CERTIFICATE OF APPROPRIATENESS

Property: 1512 South Blvd, Lot 2, Block 4, Edgemont Subdivision in Boulevard Oaks Historic District, 6,824sq ft two story single family residence with detached guest quarters. situated on a **21,784** square foot (116.75 'x 186.5') corner lot

Proposal: Alteration – Addition

Recommendation: Approval

CURRENT AERIAL/CONTEXT - SETBACKS

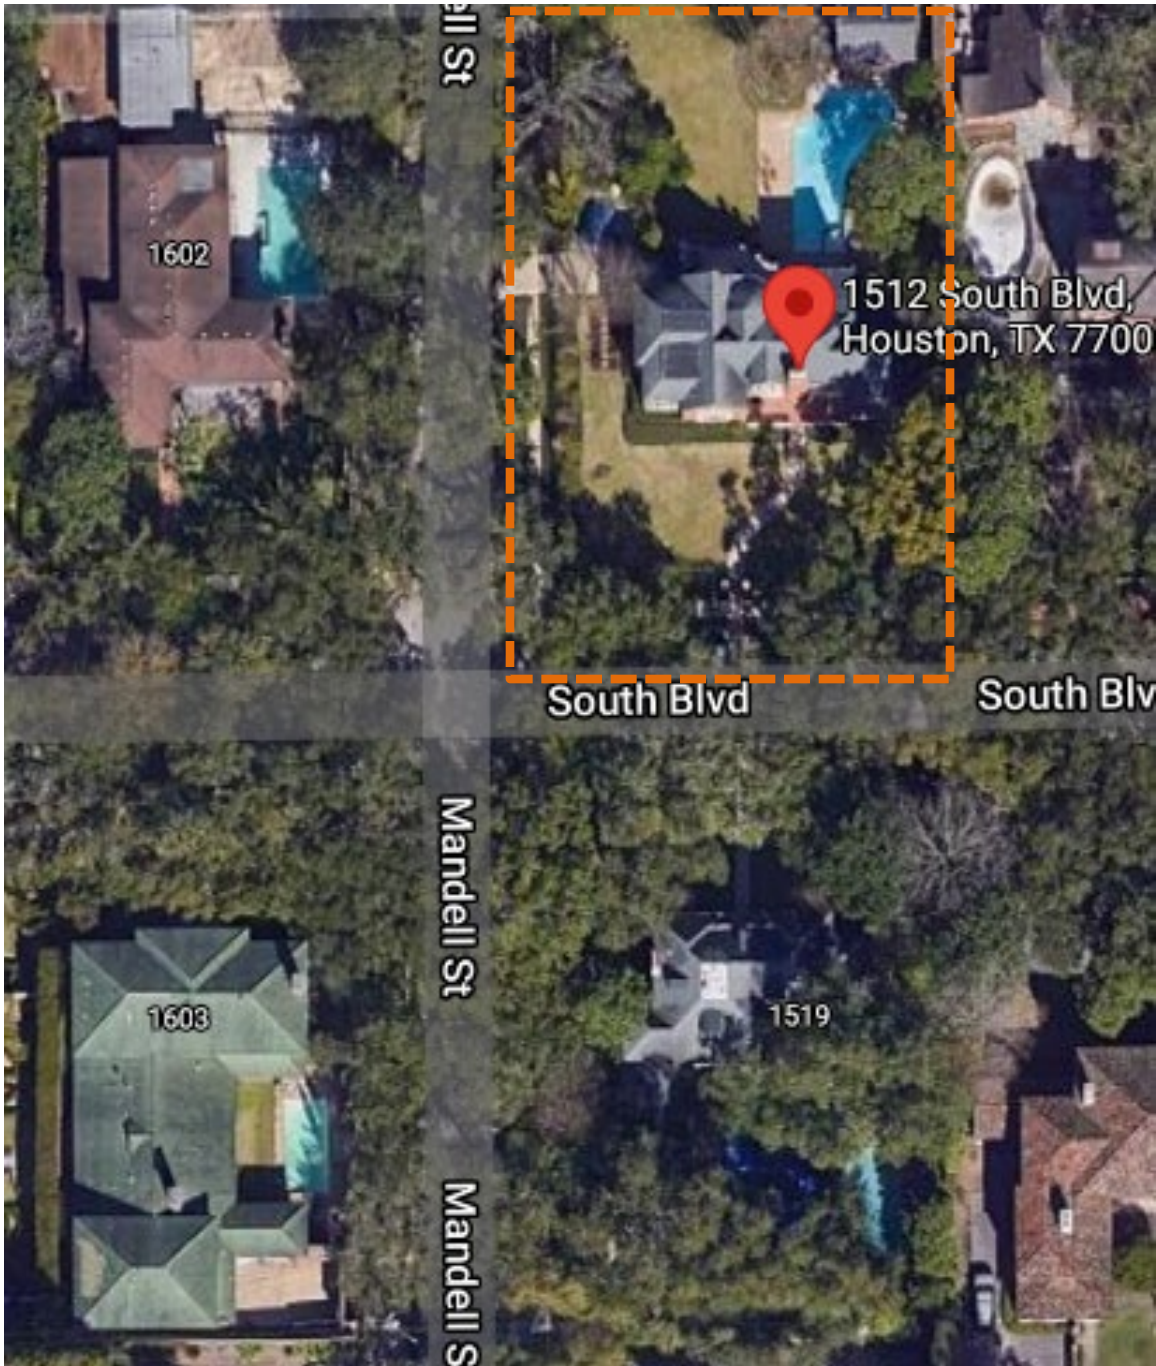
<i>Proposed addition does not impair the essential form an integrity of the historic building. The addition is set back at the rear/side of the property and does not overwhelm considering the large lot/site. Side setbacks from Mandell St. comply with 20' setbacks per the deed restrictions.</i> |

| <input checked="" type="checkbox"/> | <input type="checkbox"/> | <input type="checkbox"/> | (11) The distance from the property line to the front and side walls, porches, and exterior features of any proposed addition or alteration must be compatible with the distance to the property line of similar elements of existing contributing structures in the context area. <i>Side setbacks from Mandell St. comply with 20' setbacks per the deed restrictions compare to other contributing context.</i> |
